CERTIFICATE OF APPROPRIATENESS

Property: 848 Heights Boulevard, Lot 24, Block 247, Houston Heights South Subdivision. The property includes a historic two-story brick single-family residence and an attached garage situated on a 5,000 square foot (50' x 100') interior lot.

Proposal: Alteration – Windows. Revision. The applicant has removed all 31 of the original historic windows on the house without a COA and has installed new wood windows.

HAHC Action: Denied

LOCATION OF ORIGINAL REPLACED WINDOWS
(SUBMITTED TO STAFF MARCH 2015)

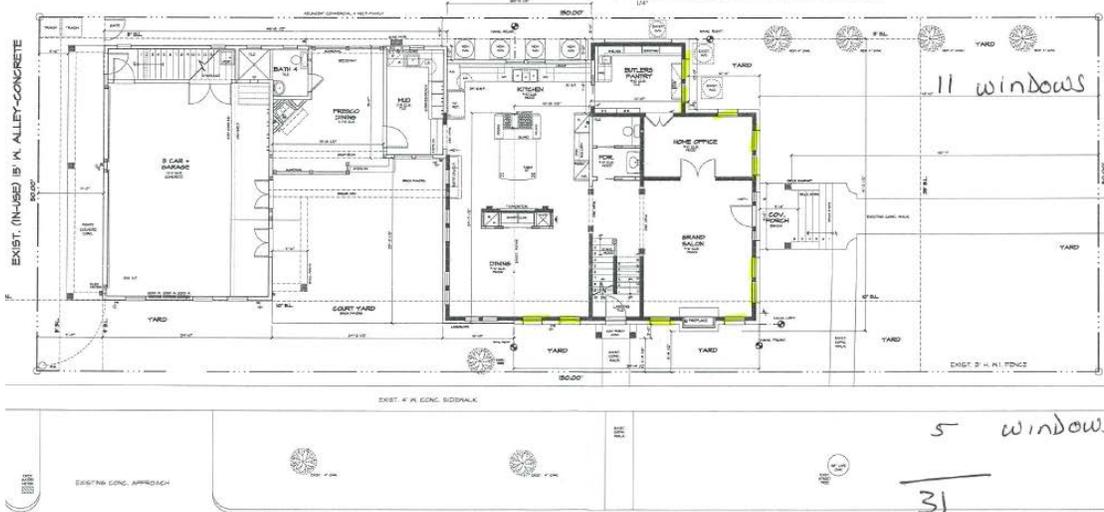
LOCATION OF ORIGINAL REPLACED WINDOWS
(SUBMITTED TO STAFF MARCH 2015)

15 windows
